HIGH POINT - GUN CLUB TO 61ST AVENUE EXTENSION INFRASTRUCTURE SITE PLAN

Date	Submission / Revision
02/28/24	1st ISP Submittal

OVERALL

Drawing Title: **LANDSCAPE PLAN**

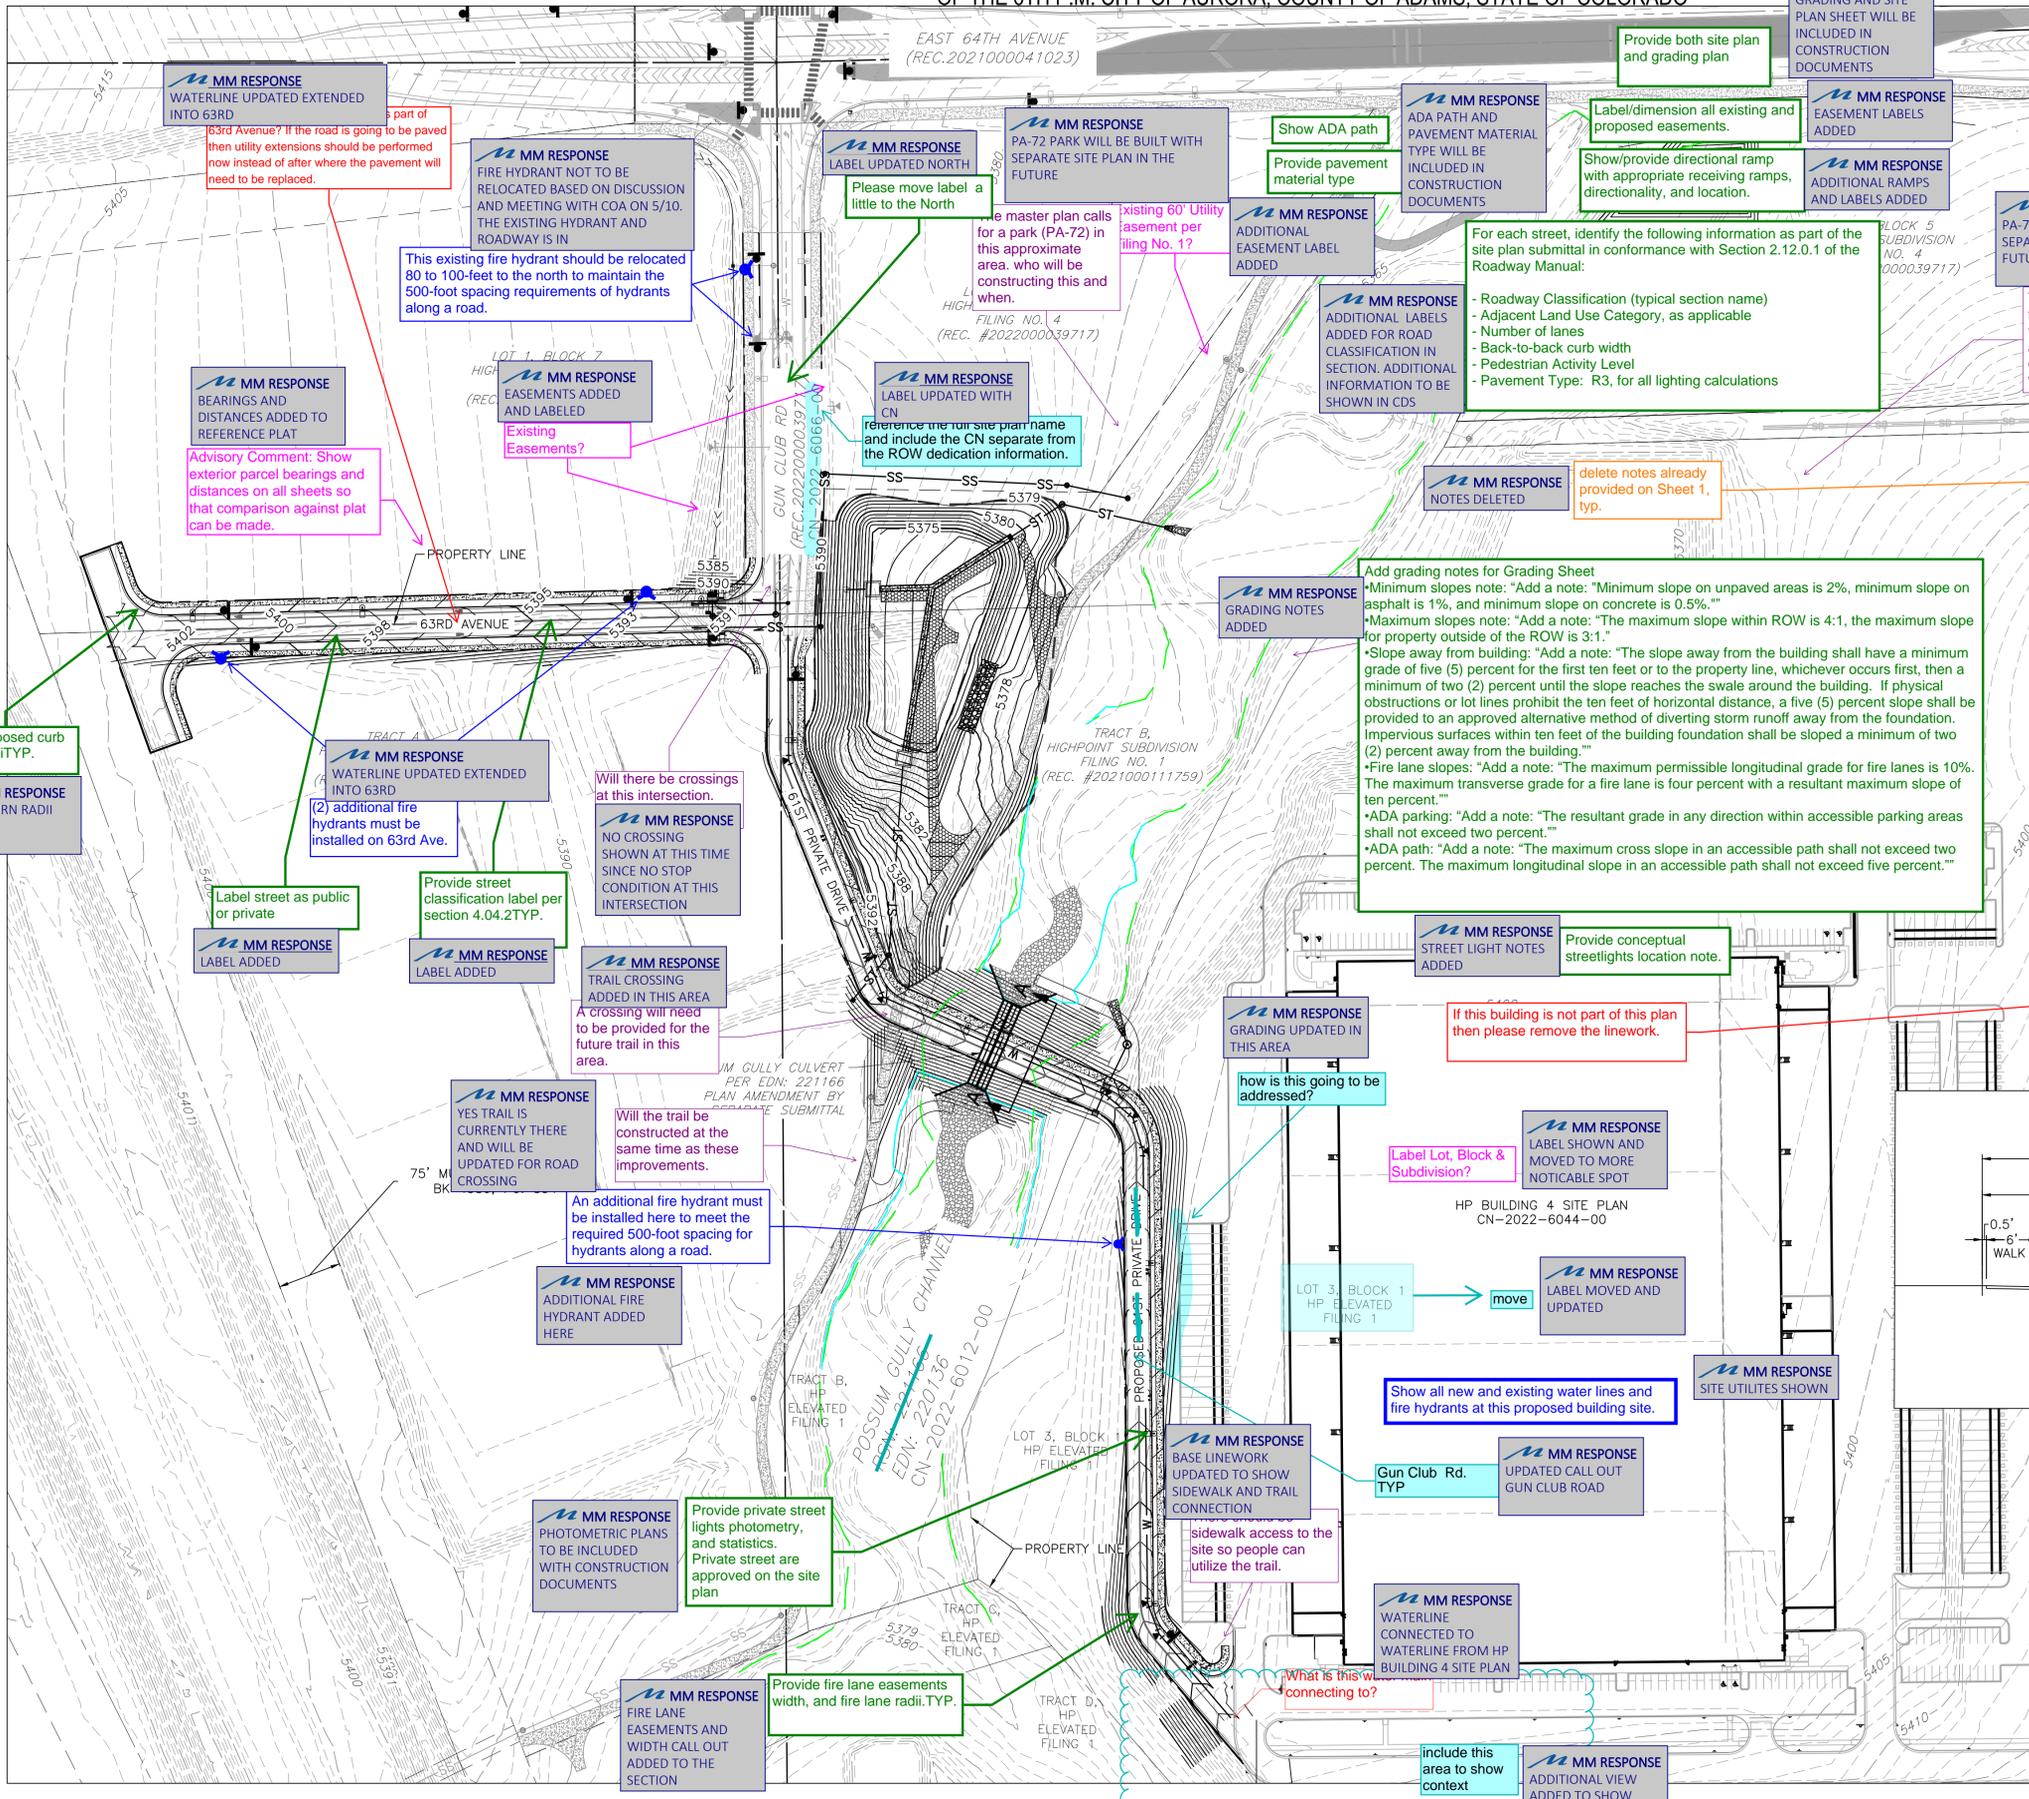
63rd Avenue? If the road is going to be paved then utility extensions should be performed now instead of after where the pavement will need to be replaced.

This existing fire hydrant should be relocated 80 to 100-feet to the north to maintain the 500-foot spacing requirements of hydrants along a road.

Advisory Comment: Show exterior parcel bearings and distances on all sheets so that comparison against plat can be made.

Existing Easements?

Please move label a little to the North

The master plan calls for a park (PA-72) in this approximate area, who will be constructing this and when.

Provide pavement material type

Label/dimension all existing and proposed easements.

Show/provide directional ramp with appropriate receiving ramps, directionality, and location.

For each street, identify the following information as part of the site plan submittal in conformance with Section 2.12.0.1 of the Roadway Manual:

- Roadway Classification (typical section name)
- Adjacent Land Use Category, as applicable
- Number of lanes
- Back-to-back curb width
- Pedestrian Activity Level
- Pavement Type: R3, for all lighting calculations

delete notes already provided on Sheet 1, typ.

Add grading notes for Grading Sheet

-Minimum slopes note: "Add a note: "Minimum slope on unpaved areas is 2%, minimum slope on asphalt is 1%, and minimum slope on concrete is 0.5%.""

-Maximum slopes note: "Add a note: "The maximum slope within ROW is 4:1, the maximum slope for property outside of the ROW is 3:1.""

-Slope away from building: "Add a note: "The slope away from the building shall have a minimum grade of five (5) percent for the first ten feet or to the property line, whichever occurs first, then a minimum of two (2) percent until the slope reaches the swale around the building. If physical obstructions or lot lines prohibit the ten feet of horizontal distance, a five (5) percent slope shall be provided to an approved alternative method of diverting storm runoff away from the foundation. Impervious surfaces within ten feet of the building foundation shall be sloped a minimum of two (2) percent away from the building.""

-Fire lane slopes: "Add a note: "The maximum permissible longitudinal grade for fire lanes is 10%. The maximum transverse grade for a fire lane is four percent with a resultant maximum slope of ten percent.""

-ADA parking: "Add a note: "The resultant grade in any direction within accessible parking areas shall not exceed two percent.""

-ADA path: "Add a note: "The maximum cross slope in an accessible path shall not exceed two percent. The maximum longitudinal slope in an accessible path shall not exceed five percent.""

Provide conceptual streetlights location note.

how is this going to be addressed?

Label Lot, Block & Subdivision?

Show all new and existing water lines and fire hydrants at this proposed building site.

What is this connecting to?

A crossing will need to be provided for the future trail in this area.

Will the trail be constructed at the same time as these improvements.

An additional fire hydrant must be installed here to meet the required 500-foot spacing for hydrants along a road.

Provide private street lights photometry, and statistics. Private street are approved on the site plan

Provide fire lane easements width, and fire lane radii.TYP.

The master plan calls for a park (PA-73) in this approximate area, who will be constructing this and when.

MM RESPONSE
WATERLINE UPDATED EXTENDED INTO 63RD

MM RESPONSE
FIRE HYDRANT NOT TO BE RELOCATED BASED ON DISCUSSION AND MEETING WITH COA ON 5/10. THE EXISTING HYDRANT AND ROADWAY IS IN

MM RESPONSE
BEARINGS AND DISTANCES ADDED TO REFERENCE PLAT

MM RESPONSE
EASEMENTS ADDED AND LABELED

MM RESPONSE
LABEL UPDATED NORTH

MM RESPONSE
PA-72 PARK WILL BE BUILT WITH SEPARATE SITE PLAN IN THE FUTURE

MM RESPONSE
Show ADA path

MM RESPONSE
ADDITIONAL EASEMENT LABEL ADDED

MM RESPONSE
ADDITIONAL LABELS ADDED FOR ROAD CLASSIFICATION IN SECTION. ADDITIONAL INFORMATION TO BE SHOWN IN CDS

MM RESPONSE
ADA PATH AND PAVEMENT MATERIAL TYPE WILL BE INCLUDED IN CONSTRUCTION DOCUMENTS

MM RESPONSE
EASEMENT LABELS ADDED

MM RESPONSE
ADDITIONAL RAMP AND LABELS ADDED

MM RESPONSE
NOTES DELETED

MM RESPONSE
GRADING NOTES ADDED

MM RESPONSE
STREET LIGHT NOTES ADDED

MM RESPONSE
GRADING UPDATED IN THIS AREA

MM RESPONSE
LABEL SHOWN AND MOVED TO MORE NOTICABLE SPOT

MM RESPONSE
LABEL MOVED AND UPDATED

MM RESPONSE
SITE UTILITIES SHOWN

MM RESPONSE
WATERLINE CONNECTED TO WATERLINE FROM HP BUILDING 4 SITE PLAN

MM RESPONSE
ADDITIONAL VIEW ADDED TO SHOW THIS AREA

MM RESPONSE
TRAIL CROSSING ADDED IN THIS AREA

MM RESPONSE
YES TRAIL IS CURRENTLY THERE AND WILL BE UPDATED FOR ROAD CROSSING

MM RESPONSE
ADDITIONAL FIRE HYDRANT ADDED HERE

MM RESPONSE
PHOTOMETRIC PLANS TO BE INCLUDED WITH CONSTRUCTION DOCUMENTS

MM RESPONSE
FIRE LANE EASEMENTS AND WIDTH CALL OUT ADDED TO THE SECTION

PA-73 PARK WILL BE BUILT WITH SEPARATE SITE PLAN IN THE FUTURE
